SPM 11-030

Subject: GNF-A Response to NRC Request for Additional Information Dated 12/23/10
for Model No. RAJ-II Package

NRC RAI for RAJ-II Package – Docket No. 71-9309, TAC No. L24456:**Editorial Requests:**

Figure 2-10.2. Comparison of RAJ-II Top Drop and LS-DYNA results (Inner Container Shell).

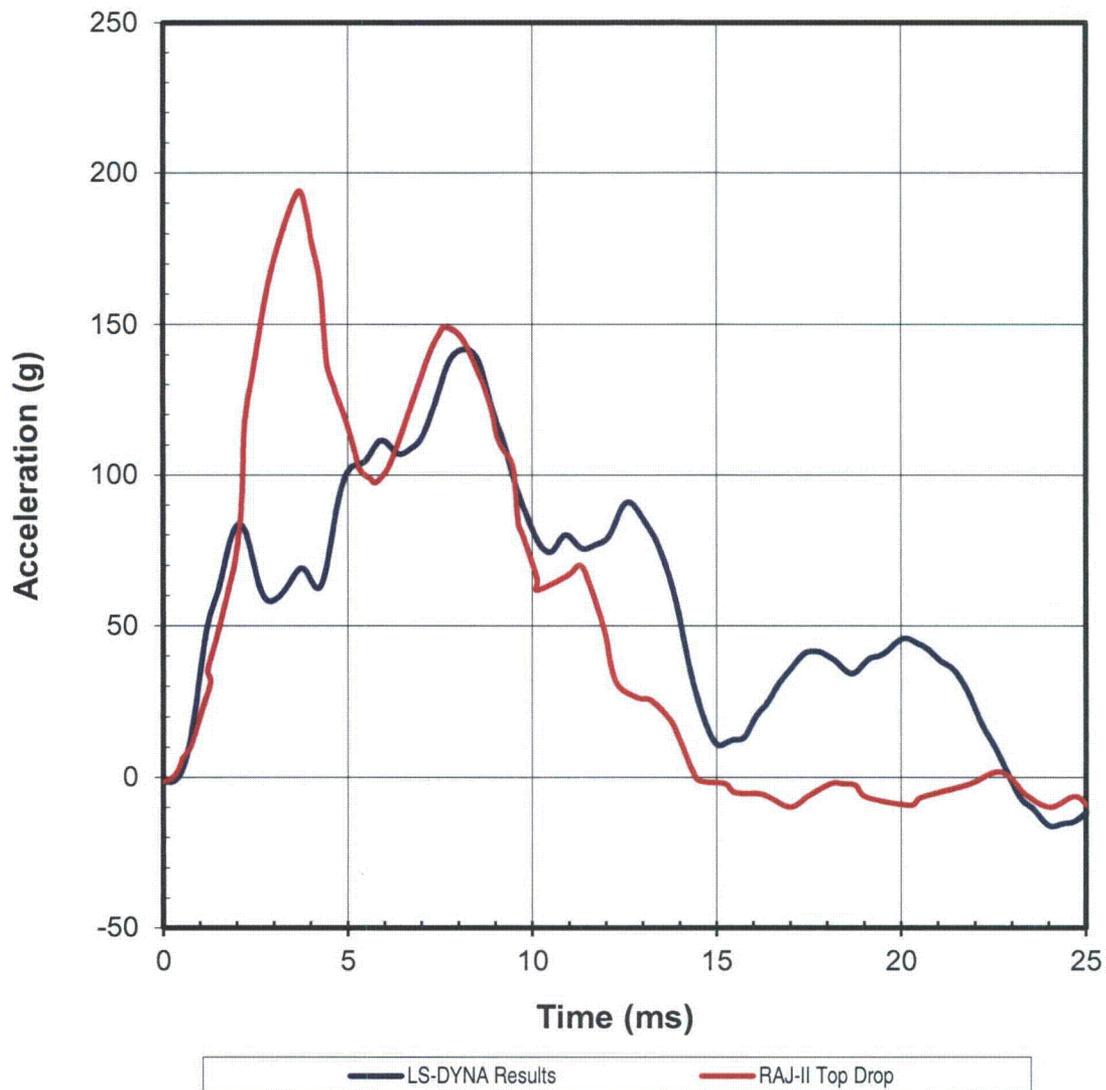
2-20 Provide overlay plots of the acceleration time histories for CTUs and FEA models. Acceleration time history shape as well as peak values are important to verify whether an analytical model is sufficiently robust to capture dynamic behavior.

The following figure is a comparison of the Japanese RAJ-II top drop with the accelerometer located on the side of the inner container. Because the exact location of the sensor is not documented, an average of 4 nodes along the length of the inner container is used to represent the LS-DYNA responses. The LS-DYNA results show good agreement with the drop test results.

Figure 6-3 Fuel bundle model – GNF 10x10 and 9x9 (top) and Westinghouse 10x10 (bottom)

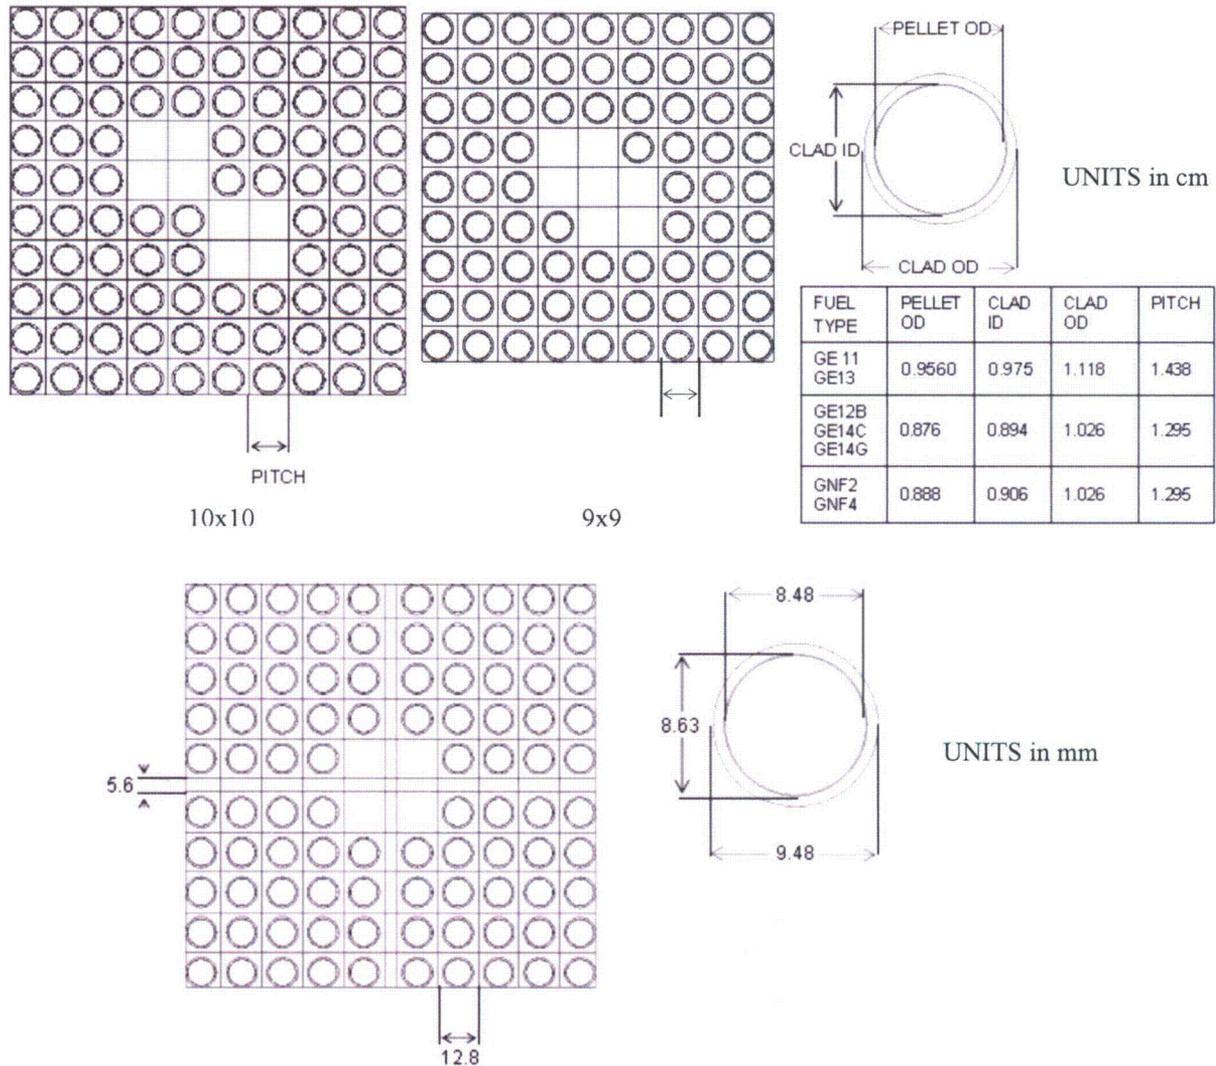
Revise Figure 6-3 of the SAR to include a similar schematic for one of the 9x9 fuel assemblies (either the GE11 or GE13).

This figure provides a schematic layout for several 10x10 fuel assemblies, but does not provide a similar representation of the 9x9 fuel assembly contents. The SAR should be revised to show a representation of the 9x9 fuel assembly.

Figure 6-3 updated to include 9x9 fuel layout, as follows:

Figure Error! No text of specified style in document.-Xa Fuel Rod without a Rod Container, Pitch Variation – Square Pitch (top) and Hexagonal Pitch (bottom)

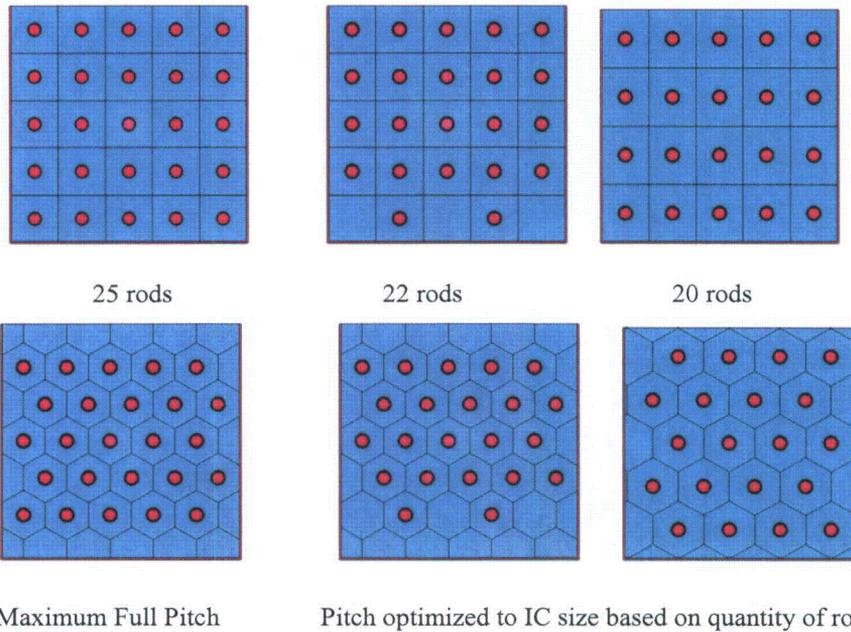
Revise Section 6.6.2.1.2 of the SAR to clarify the rod pitches evaluated for the fuel rods without rod containers.

Table 6-37 of this section shows evaluated rod pitches of rod outer radius, 1.3 inches, and 1.6 inches, with reported keff increasing with pitch. The SAR should clarify that this largest pitch evaluated is the largest that the inner container will allow for the 25 rod limit. Additionally, if this is the largest pitch allowed by the package dimensions, the SAR should demonstrate that larger pitches with fewer rods are not more reactive.

The pitch shape is modeled as either a hexagonal or square pitch array (see Figure 6-Xa for pitch comparison). Table 6-37b displays k_{eff} results for a comparison of the pitch shape for the most reactive fuel rod contents, PWR_W3, for shipment with no rod container (determined in Table 6-37a). The largest variation, an increase in k_{eff} for a square pitch over hexagonal pitch, occurs when rods are tight packed. However, as the pitch is increased and/or the quantity of rods decreases then the hexagonal pitch array becomes more reactive due to optimization of the moderator-to-fuel ratio.

Figure 6-6 WEC Rod Box: SCALE Model slice (left), Licensing Drawing (right)

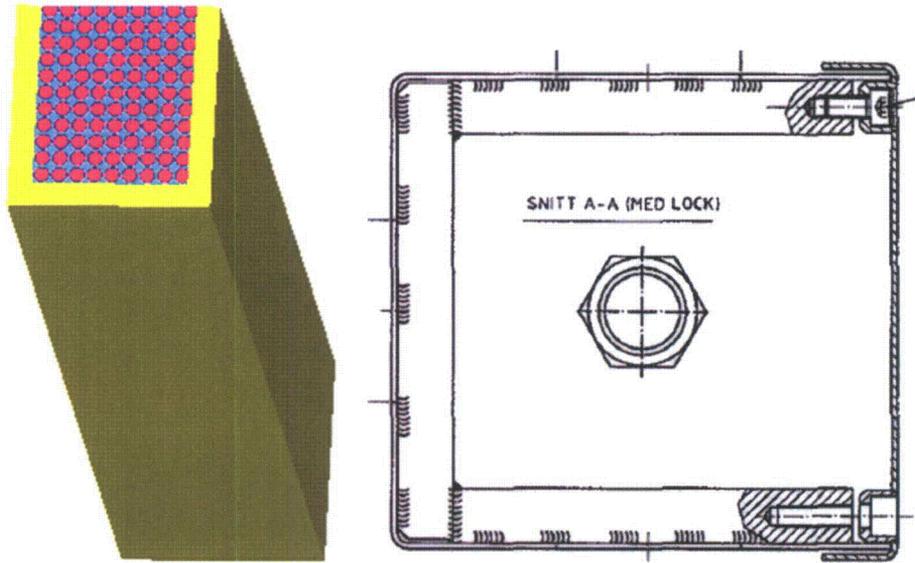
Revise Section 6.3.1.3 of the SAR to clarify the modeling of the WEC rod box for shipping loose fuel rods.

This section states that the WEC rod box shell has large punched holes, which are modeled as solid in the criticality model configuration. Modeling the rod box this way may be non-conservative, as it reduces the water volume and increases parasitic neutron absorption in the steel. This section should be revised to justify that this modeling simplification is conservative.

The WEC rod box is a rectangular box, composed of an external shell and internal steel bars limiting the contents spacing. The shell has large punched holes to avoid water moderation buildup within the container. Conservatively, no components of the WEC rod box are modeled, although the internal spacing is maintained and fully moderated for hypothetical accident transport conditions.

Figure 6-1 Polyethylene Cluster Separator

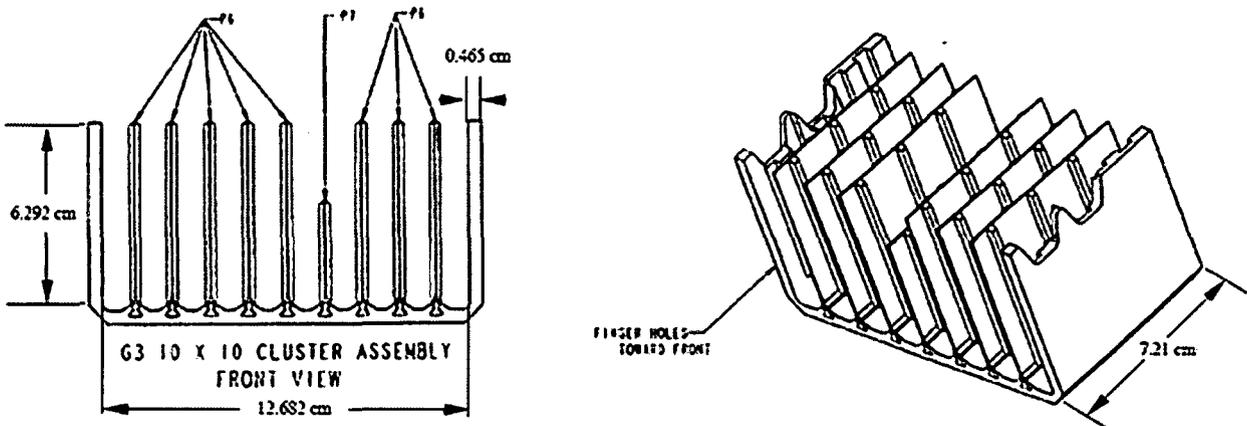
Revise the application to clarify why the polyethylene in the criticality model configuration is represented as a mixture of actual densities, and if it is conservative to do so. Also, clarify the equation used to combine the densities, as PI does not appear in the equation, and both PI and Pr are listed as the density of the mixture. Additionally, clarify why a volume weighted density is used for the normal conditions of transport model, while the standard material density is used for hypothetical accident conditions, and how this modeling approach is conservative. Lastly, revise the application to state the maximum mass of polyethylene that may be present in the package, and ensure that this maximum mass is considered in the criticality analysis.

When fuel assemblies are shipped without a channel as a fuel bundle, polyethylene inserts or polyethylene cluster separators are positioned between fuel rods at various locations along the axis of the fuel assembly to avoid stressing the axial grids during transportation. The cluster separators are shown in Figure 6-1 provide a higher volume average density polyethylene inventory, hence are chosen for the RAJ-II criticality analysis. The cluster separator is composed of Low Density Polyethylene (LDPE, 0.925 g/cm³) fingers and a High Density Polyethylene (HDPE, 0.959 g/cm³) holder. For a 10x10 cluster separator assembly unit, the LDPE fingers occupy an approximate volume of 38 cm³ while the HDPE holder has an approximate volume of 85 cm³. A weight average density of 0.949 g/cm³ is calculated for the polyethylene cluster assembly as a mixture of the actual densities since the cluster separator assembly is modeled as a single unit. The calculation is as follows:

$$\frac{1}{\rho_T} = \frac{\omega_{LDPE}}{\rho_{LDPE}} + \frac{\omega_{HDPE}}{\rho_{HDPE}} = \frac{0.30}{0.925} + \frac{0.70}{0.959} = 1.054$$

Figure 6-2 SCALE Unit Cell Demonstration for Re-distribution of Polyethylene

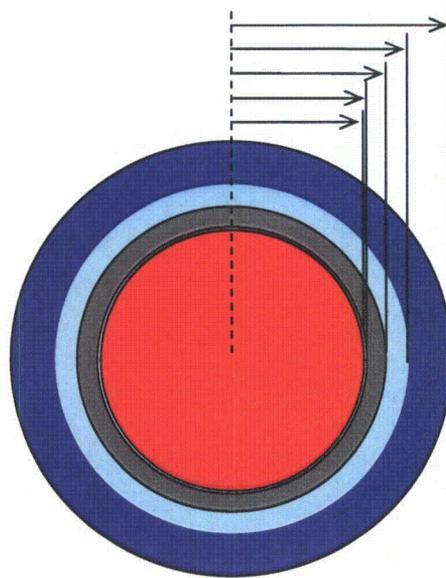
Revise Section 6.3.4.1.2 of the SAR to demonstrate how the moderator radius is defined in the cylindrical multiregion unit cell used to correct for resonance self-shielding. Additionally, clarify if this unit cell is used only in the lattice pitch expansion evaluation, or whenever polyethylene packing materials are assumed to be in the lattice.

On p 6-39 of the SAR, the applicant states that "the effect of polyethylene packing materials on resonance self shielding is accounted for in the cross-section processing by specifying a cylindrical multiregion-unit cell as shown in Figure 6-13." This section should be revised to clarify if a uniform lattice is considered, and how the radius is corrected to preserve the Dancoff factor. Also, although this discussion appears in the lattice expansion section of the analysis, it appears that this unit cell approximation would be necessary any time there is polyethylene in the lattice, which also occurs in the unexpanded lattice. The applicant should clarify if this approach is used for resonance self-shielding calculations elsewhere in the analysis, and if not, what approach is used.

In addition to the geometry representation in the model, the effect of polyethylene packing materials on resonance self shielding is accounted for in the cross-section processing by specifying a cylindrical multiregion unit cell as shown in Figure 6-13. The lattice effects are approximated by applying a white boundary condition to the cylindrical multiregion unit to represent a uniform lattice. Although the geometric lattice cell may be hexagonal or square, the moderator region is converted to a cylindrical geometry for cross-section processing by the multiregion unit celldata. The moderator cylindrical radius is calculated preserving area by setting the moderator lattice cell area (i.e., square or hexagonal region) equal to the cylindrical area and solving for the radius (MODR). Conversion equations are shown below for a square and hexagonal geometry, respectively:
